Change No. 4  
License No. DPR-20

APPENDIX B  
TO  
PROVISIONAL OPERATING LICENSE DPR-20  
INTERIM SPECIAL TECHNICAL SPECIFICATIONS  
FOR THE  
PALISADES PLANT  
CONSUMERS POWER COMPANY  
DOCKET NO. 50-255

Date of Issuance: March 2, 1973

FIGURE 2-4

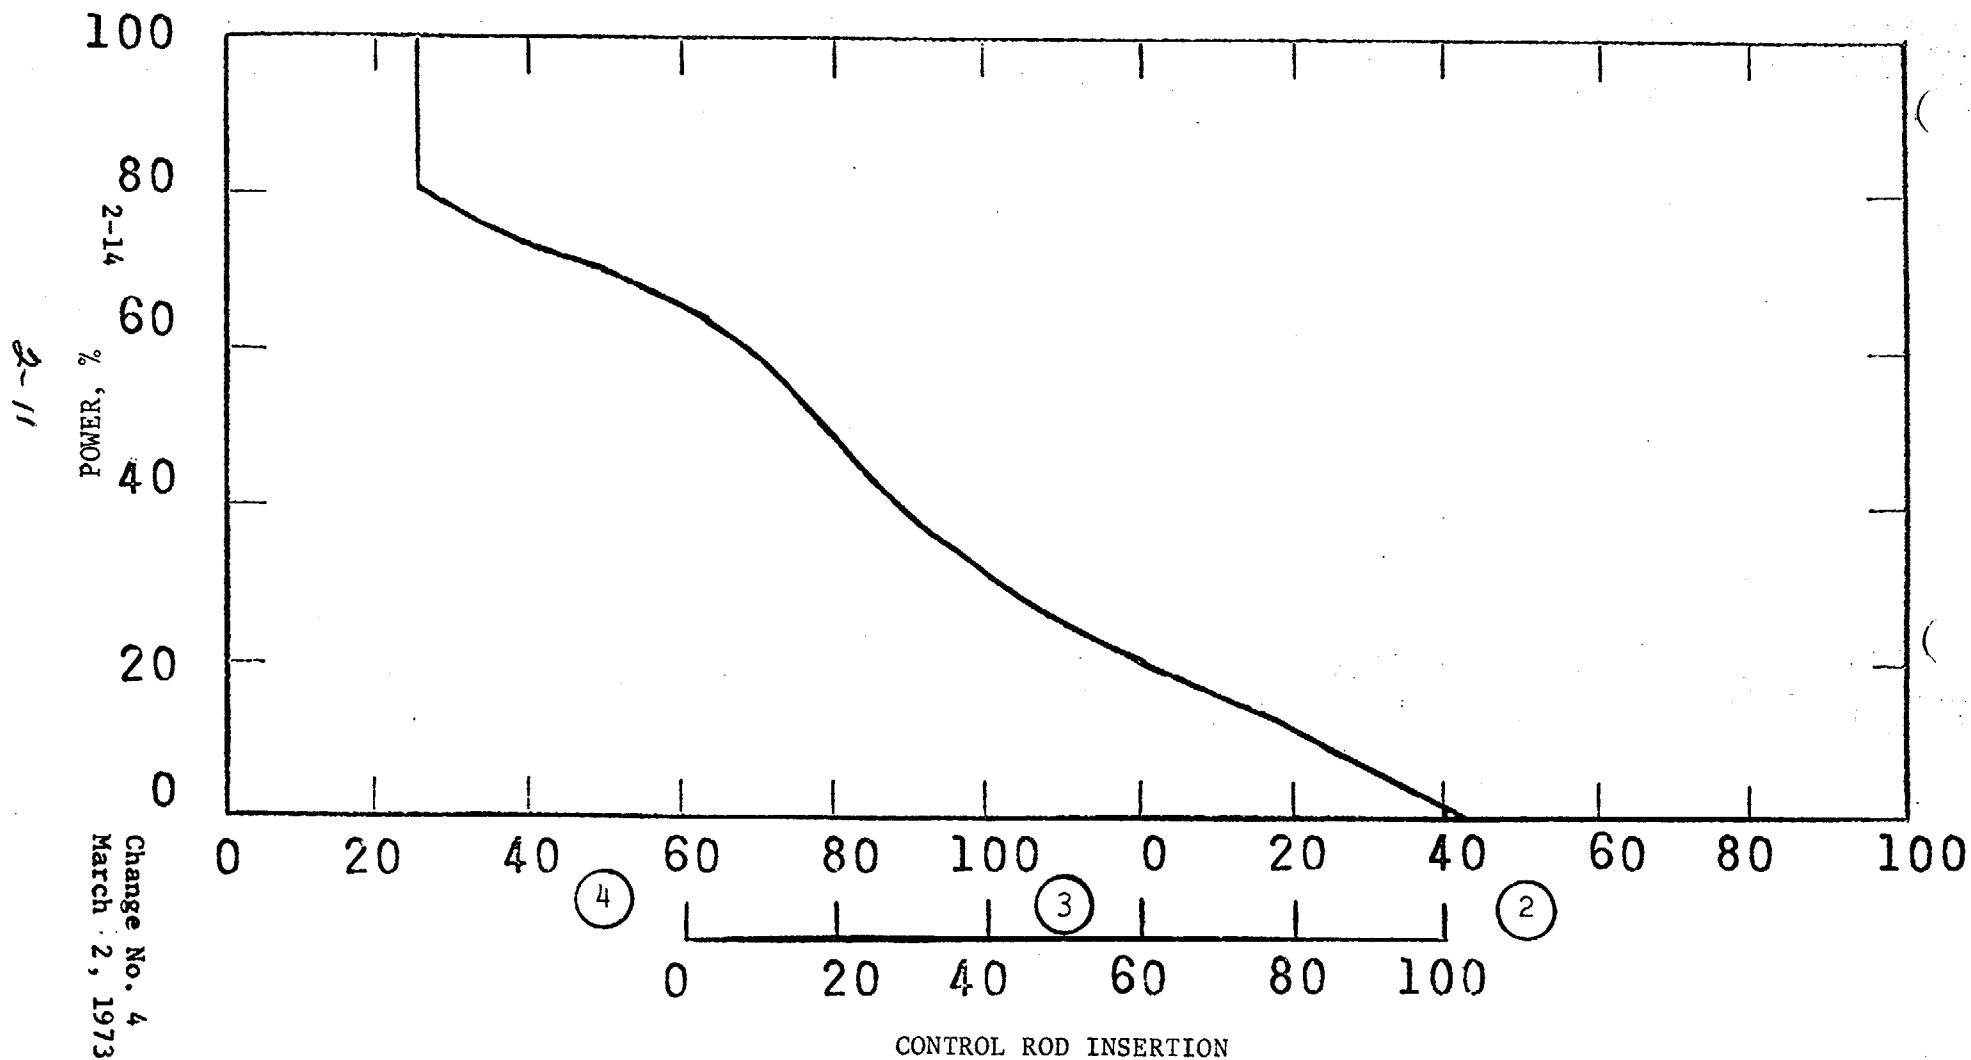
The corollary thermal and hydraulic design bases for the settings are set forth in Section 3 of the FSAR. For four primary coolant pump operation at nominal operating pressures of 1900 psia or greater, the low-pressure trip (LP) of 1750 psia causes a reactor trip in the unlikely event of a loss-of-coolant accident. Similarly, for four primary coolant pump operation at nominal operating pressures of less than 1900 psia, the low-pressure trip of 1650 psia causes a reactor trip in the unlikely event of a loss-of-coolant accident. Operation with a nominal operating pressure of less than 1900 psia will be in accordance with Figure 2-4.

PALISADES PLANT  
CONTROL ROD INSERTION LIMITS  
ALLOWED POWER LEVEL (% OF 2200 Mw<sub>t</sub>) VS CONTROL ROD INSERTION (%) BY ROD GROUP  
FOR OPERATION BELOW 1900 psia

FIGURE B-1

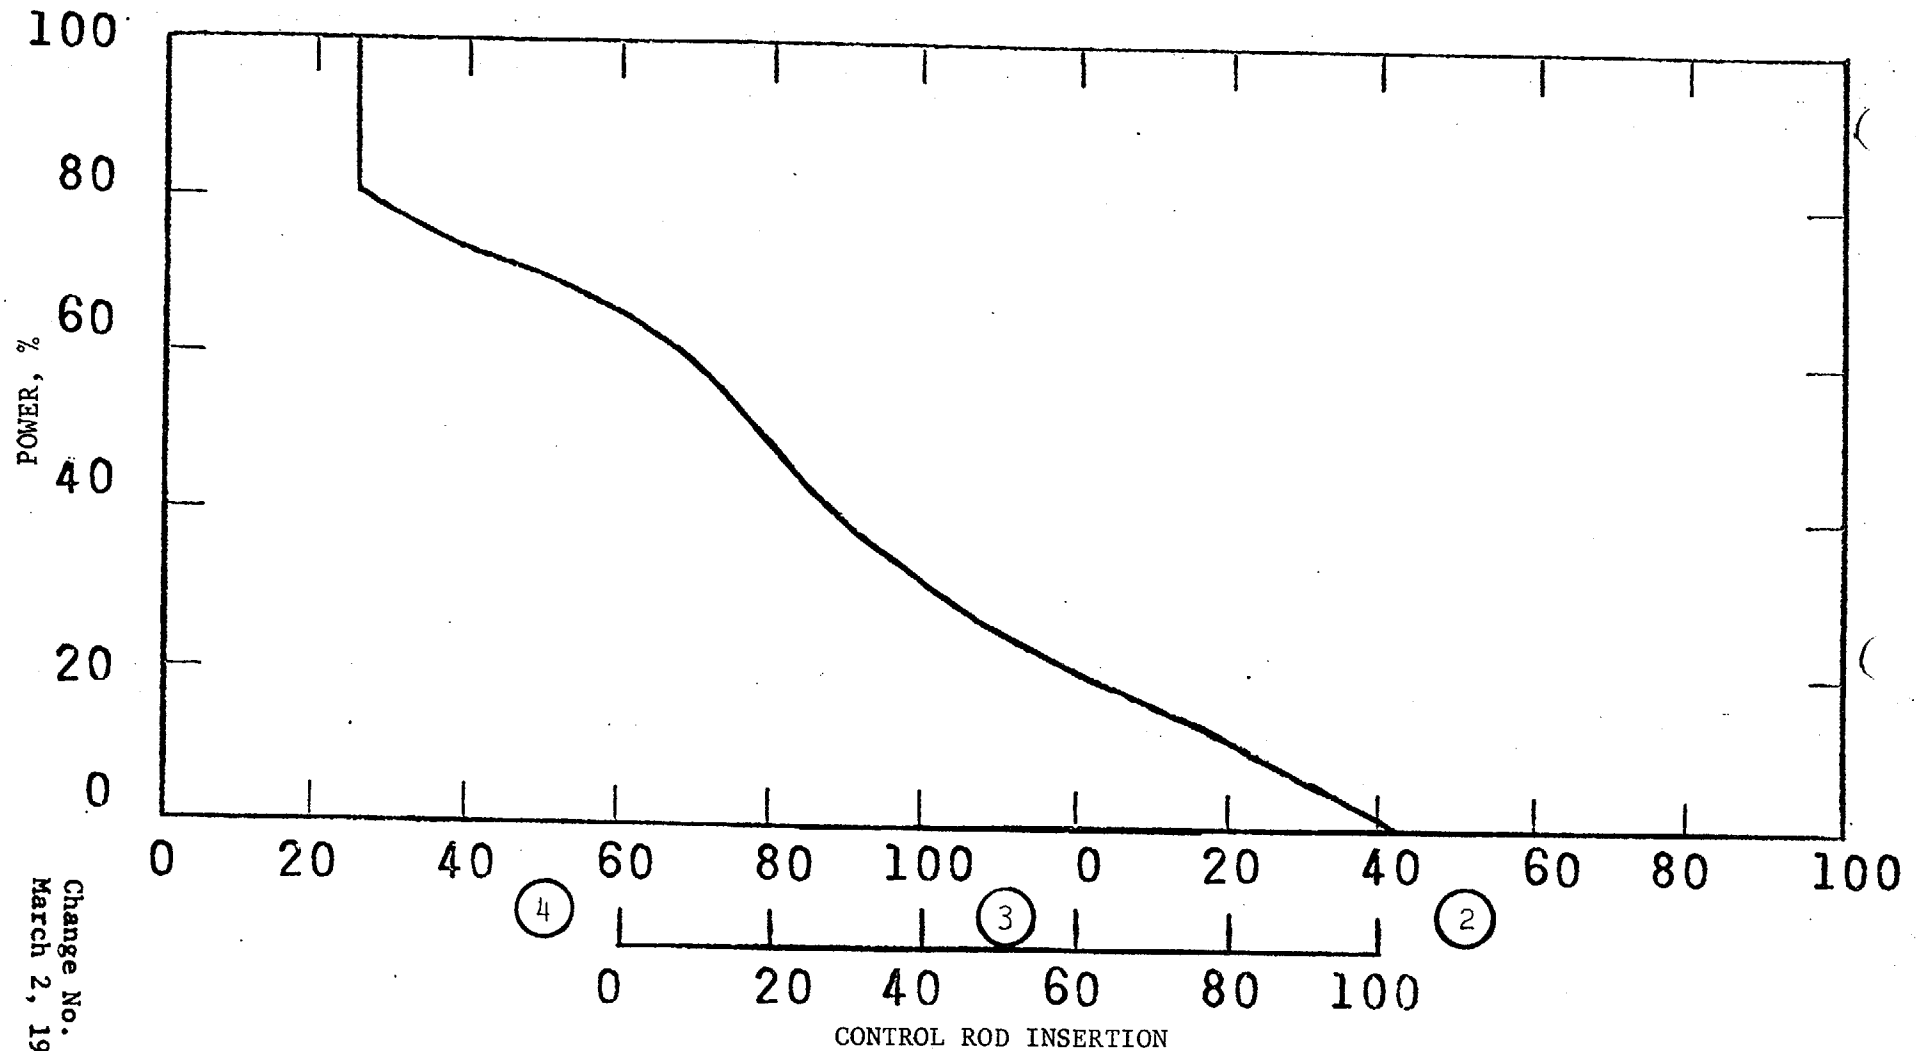
- 4. Nominal primary system operating pressure shall not exceed 1800 psia.
- 5. If at the end of the 1500 effective full power hour period additional information has not been submitted and approved by the Directorate of Licensing, the power level will be reduced immediately to 1320 MWt.
- 6. The data logger can be inoperable for two hours. If at the end of two hours, it is not available, the power level shall not exceed 70% of full power.
- 7. Control rod insertion limits will be in accordance with Figure B-1.

PALISADES PLANT  
CONTROL ROD INSERTION LIMITS  
ALLOWED POWER LEVEL (% OF 2200 Mwt) VS CONTROL ROD INSERTION (%) BY ROD GROUP
